AGENDA

The Planning and Zoning Commission and Board of Adjustment of the City of Sherman will hold a regular meeting Tuesday, April 18, 2017 at 5:00P.M. in the Council Chambers at 220 W. Mulberry to consider the following:

STAFF REVIEW LETTER

3217 Redbud Trail

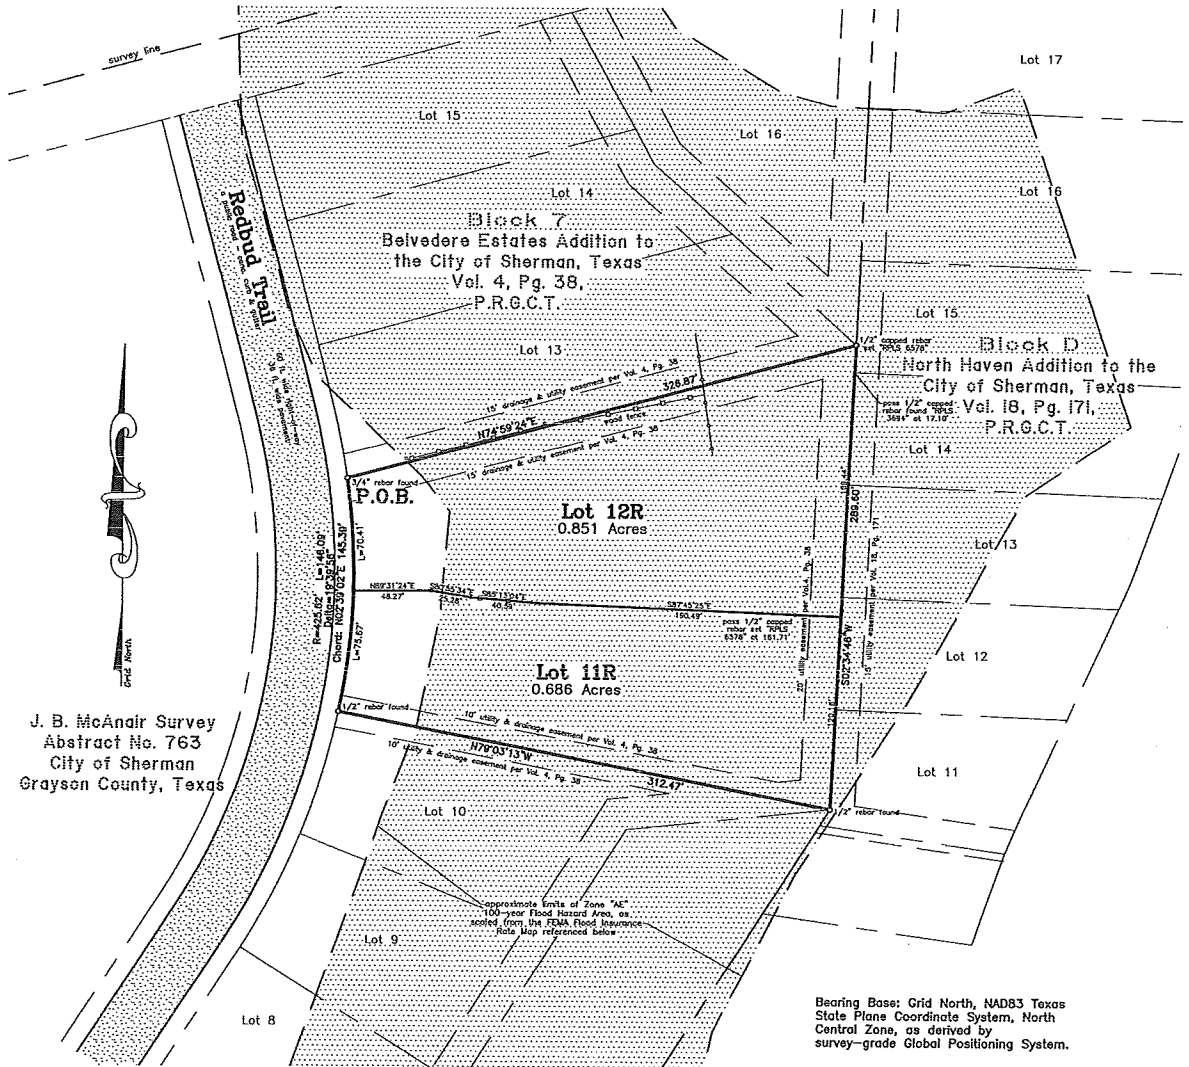
5. All requirements of the Floodplain Ordinance should be followed.
6. Calls on legal description must match drawing.
7. Show complete ownership blocks for all property owners. Also show Owners' addresses below Addition block.

SITE/DEMO PLAN

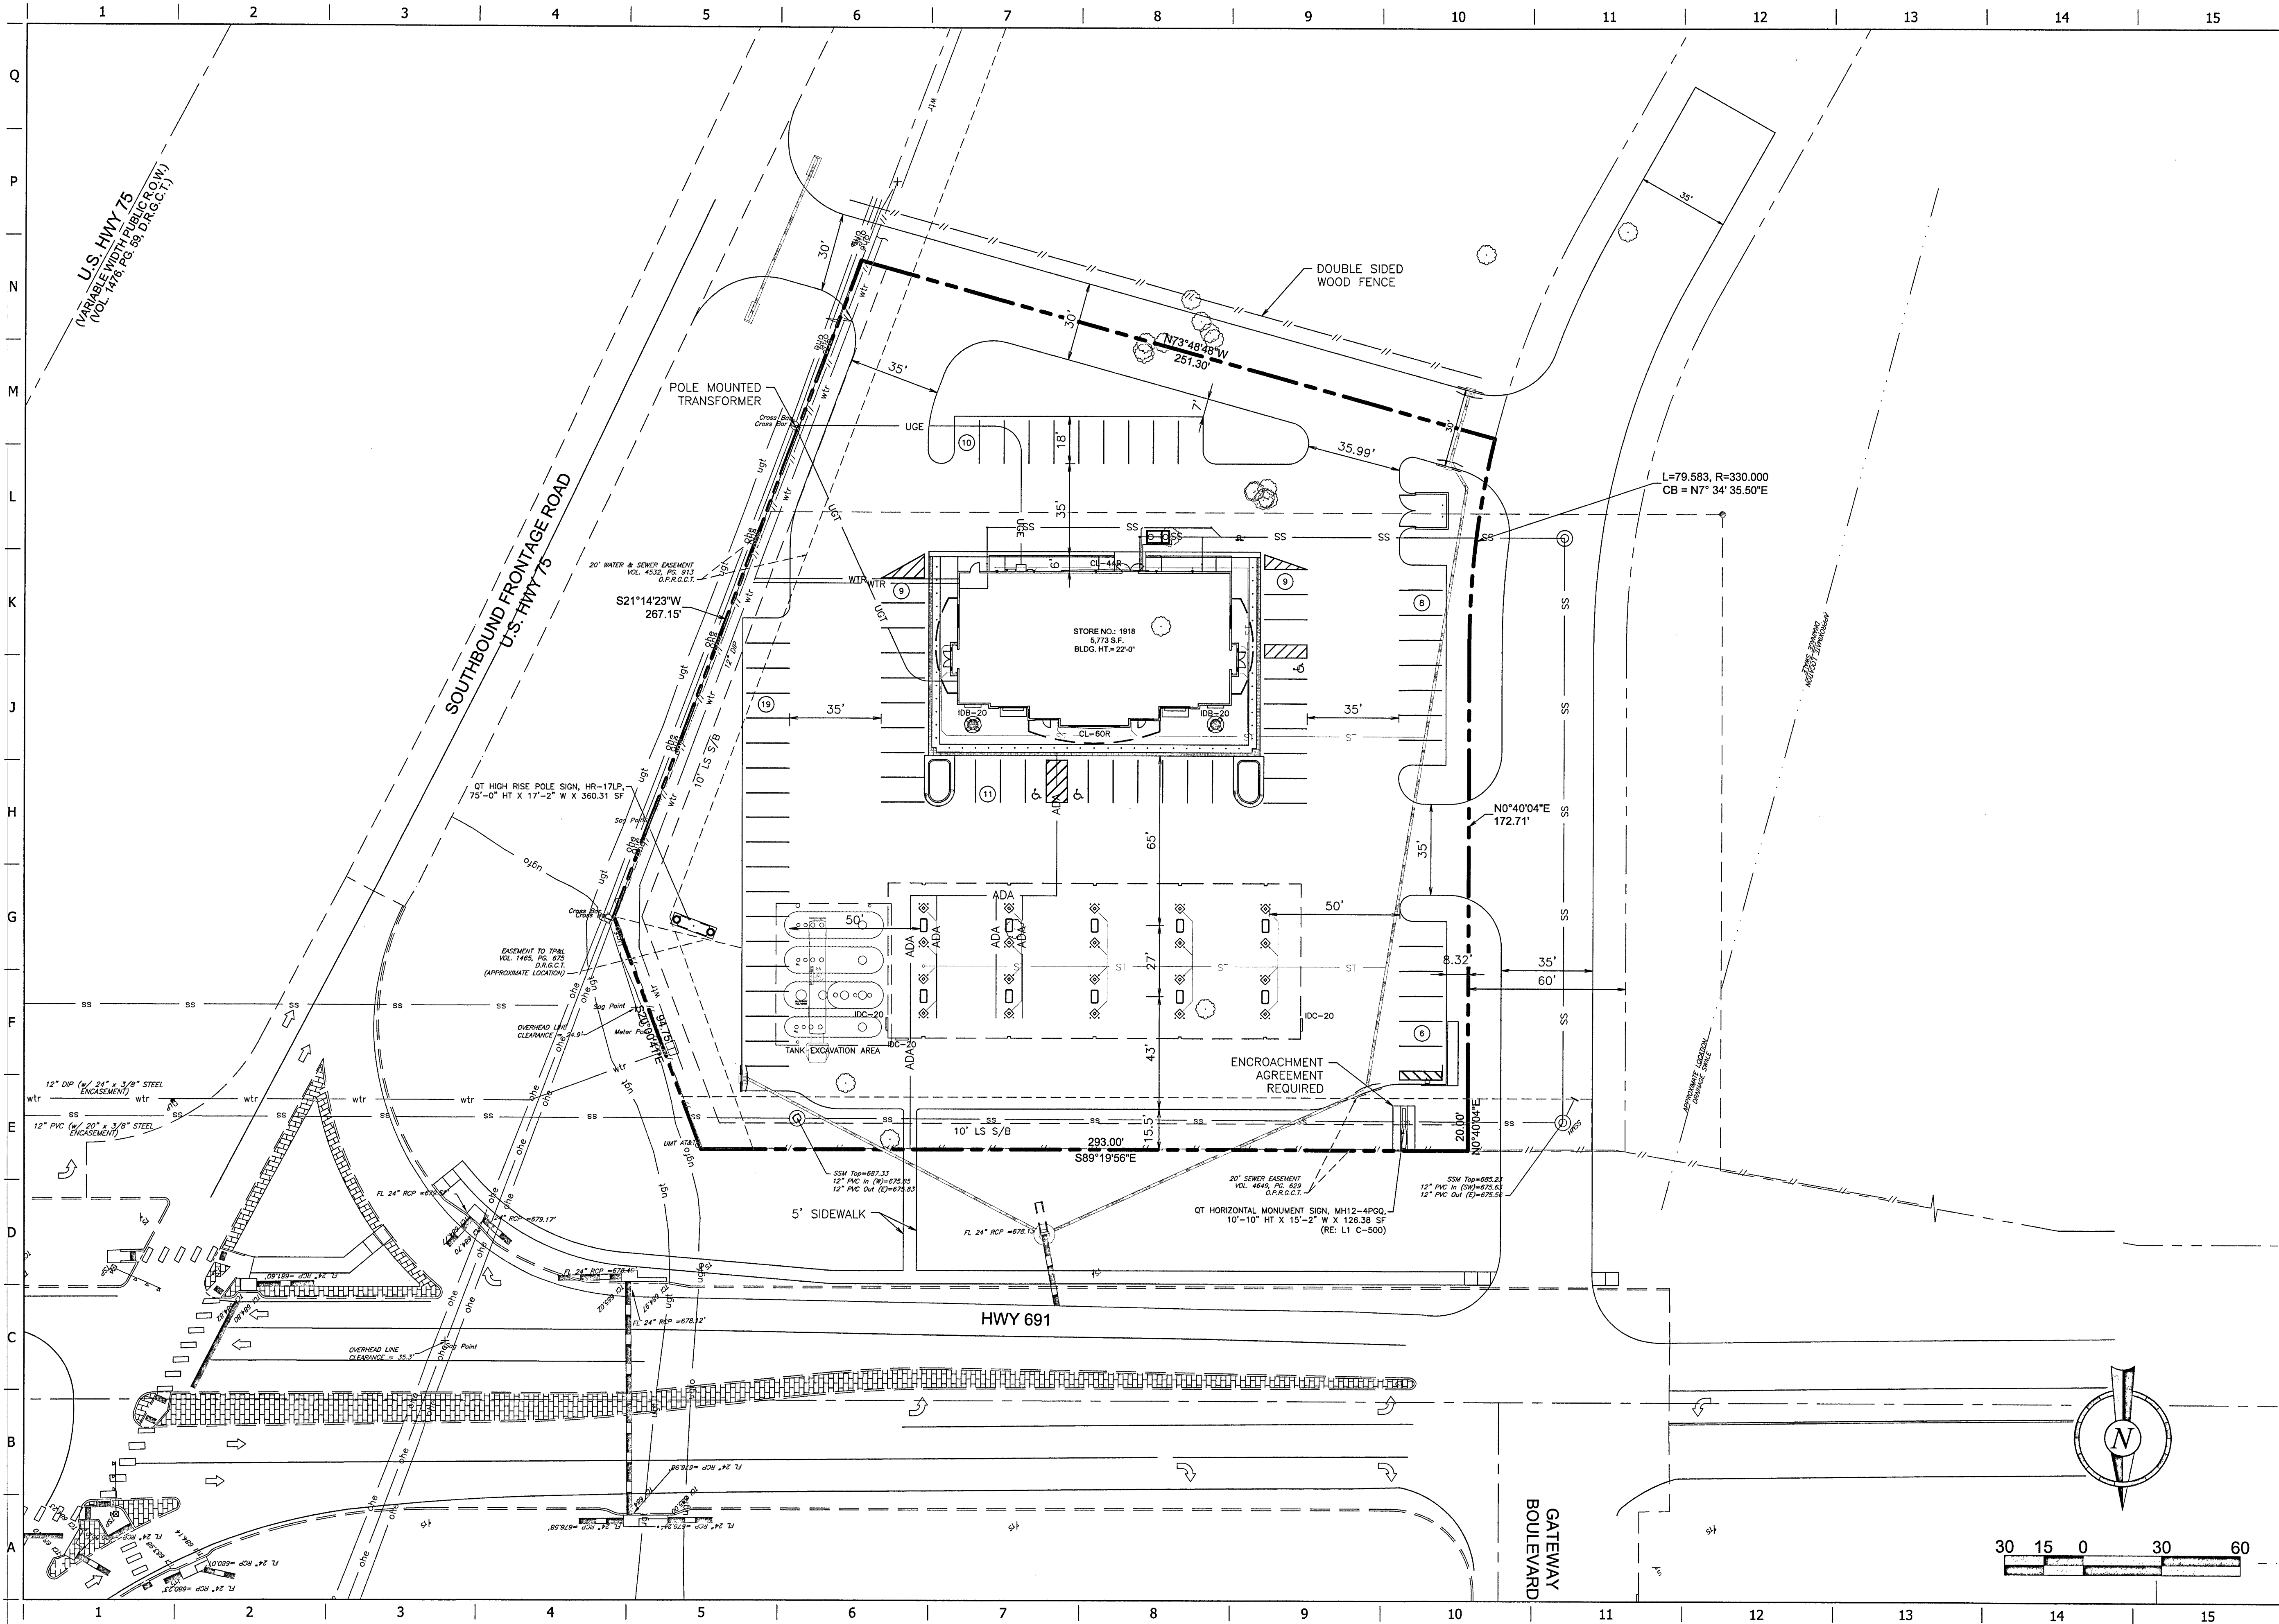
11. The trash dumpster will need to be located inside the main building area.
12. Restrict lighting in and around the windows; no flashing of intermittent lights or lights that change colors that cause a glare or brightness to a degree that constitutes a hazard or nuisance to traffic is allowed.

23. Verify fire lane requirements with Fire Marshall.
24. Street off of F.M. 691 should be a dedicated street.
25. Street off of U.S. Hwy. 75 to be a private drive with a mutual access easement.

26. Sign may have to be moved per widened easement.
27. Encroachment agreement requirement for signs within easement.
28. Final site plans, utility, drainage, and grading plan shall be provided and approved by the City Engineering Department.
